From: Richard Dollamore <richard@whaleback.co.uk>
Sent: 22 May 2026 11:45:16 UTC+01:00
To: "Andrew Horrell" <andrew.horrell@midsussex.gov.uk>
Cc: "Joanne Fisher" <joanne.fisher@midsussex.gov.uk>
Subject: RE: DM/25/3072 and 3073 The Coach House, Nether Walstead
Attachments: Ty-Mawr Sublime Literature - 2022.pdf, Indicative Construction Details 1 to10.pdf

From: Andrew Horrell <andrew.horrell@midsussex.gov.uk>
Sent: Wednesday, May 6, 2026 4:39 PM
To: Richard Dollamore <richard@whaleback.co.uk>
Subject: RE: DM/25/3072 and 3073 The Coach House, Nether Walstead

From: Emily Wade <Emily.Wade@midsussex.gov.uk>
Sent: 01 May 2026 10:03
To: Andrew Horrell <Andrew.Horrell@midsussex.gov.uk>
Cc: Joanne Fisher <Joanne.Fisher@midsussex.gov.uk>
Subject: RE: DM/25/3072 and 3073 The Coach House, Nether Walstead

Figure 6: Insulating limecrete slab
Where a decision is taken to insulate a historic floor then one option is to provide a permeable insulated floor slab as shown here. Expanded clay is used as the insulant.

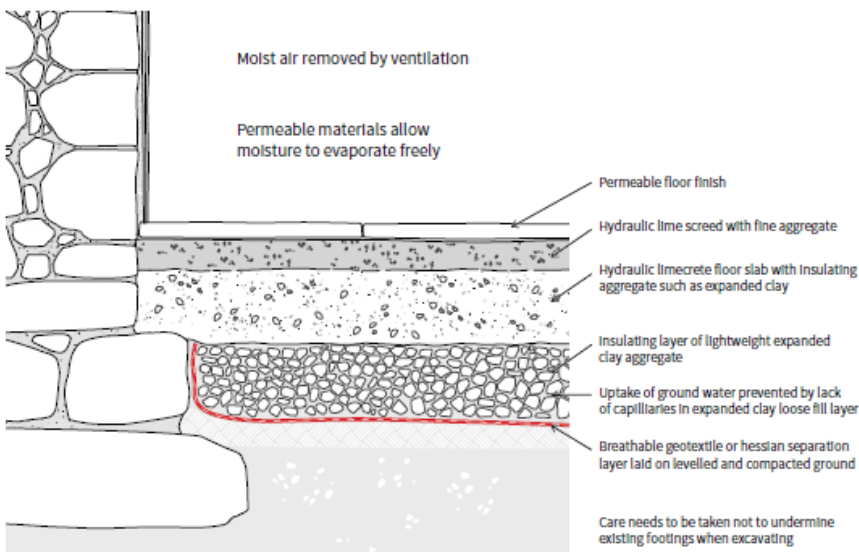
4. Further information should be provided regarding the proposed method of insulation to floor, walls and roof of the building. I would prefer to see this now rather than by condition, as it will be fundamental to the practical implementation of the scheme. We will need to see detailed typical elevations and sections which demonstrate how historic fabric which is of interest, such as the timber framing to the roof and some of the walls of the building, is retained and exposed to view.

Although it is good to note that Historic England guidance will be followed, I am afraid that we do require details to be provided at this stage rather than by condition, for the reasons set out in my initial comments. It is much better that any potential issues with this are identified and addressed now rather than problems arising after a consent is potentially granted and works commenced. This is our standard practice in dealing with conversions of traditional farm buildings of heritage value.

The proposal adopts a breathable floor build-up intended to improve thermal performance while allowing the movement and evaporation of moisture, thereby avoiding the risks associated with impermeable floor constructions in traditional buildings. The attached Ty-Mawr Sublime literature provides further indicative information. A detailed site-specific section and specification can be secured by condition following detailed investigation.
